Product Change Notification: BLAS-20WDYJ907

CCB 8229 Final Notice: Implement new carrier tape and cover tape design for AT32UC3A0512-ALUR and AT32UC3A0512-ALUT catalog part numbers (CPN) available in 144L LQFP (20x20x1.4mm) package at ANAP assembly site.

Pre and Post Change Summary

PCN #: BLAS-20WDYJ907

Pre and Post Change Summary – Carrier Tape

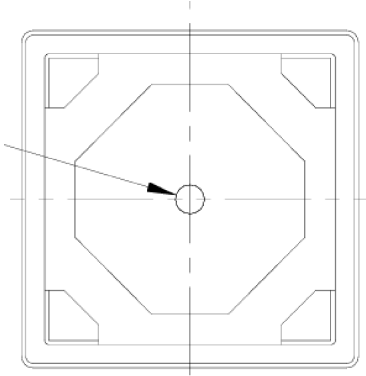
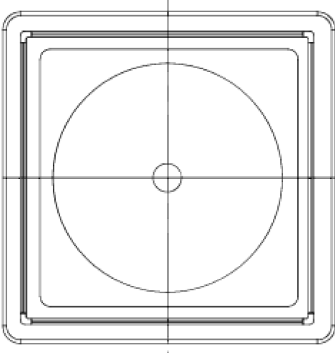
Plant	Ao	Bo	Ko	K1	Tape Pitch	Tape Width	K2	Length
ANAP (Pre Change)	22.63 ± 0.10 mm	22.63 ± 0.10 mm	2.15 ± 0.10 mm	1.42 ± 0.10 mm	32.00 ± 0.10 mm	44.00 ± 0.30 mm	N/A	99m
ANAP (Post Change)	22.70 ± 0.10 mm	22.70 ± 0.10 mm	2.10 ± 0.10 mm	1.60 ± 0.10 mm	0.90 ± 0.10 mm	32.00 ± 0.10 mm	0.90 ± 0.10 mm	89m
